Active Errata List

Radiation Tolerant FIFOs

Errata Sheet

Rev. 4140A-AERO-06/02

Figure 1. Behavior Description

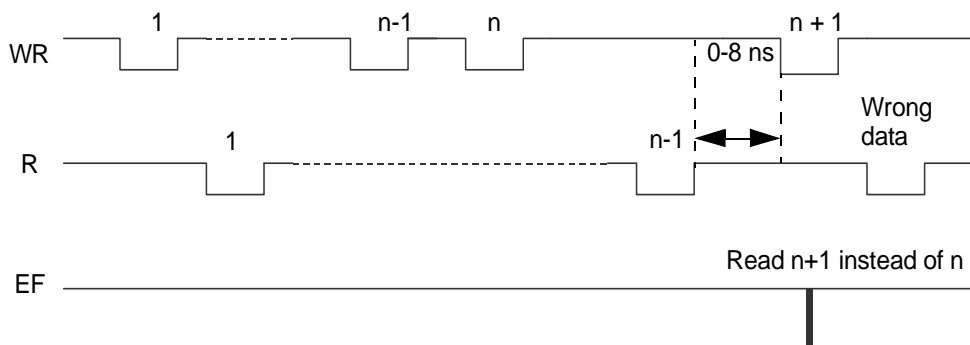
1. Limitation to the operating conditions inside a timing and data marginal configuration.

Rising edge of READ from 0 ns up to 8 ns (typical) before the falling edge of WRITE when only one data is left to read.

See Figure 1 for behavior description.

Empty flag glitch and following data shift out 2nd byte corruption occurs when the rising edge of the first "READ" for data shift out occurs before falling edge of the third "WRITE" for data shift in.

between 0 ns and 11 ns

Temperature = 125°C

Voltage = 4.5V

-55°C / 5.5V: 6 ns

25°C / 5V: 8 ns

125°C / 4.5V: 11 ns

These FIFOs are functional outside of the above timing and data marginal configuration.

The recommended action is to avoid this particular configuration.
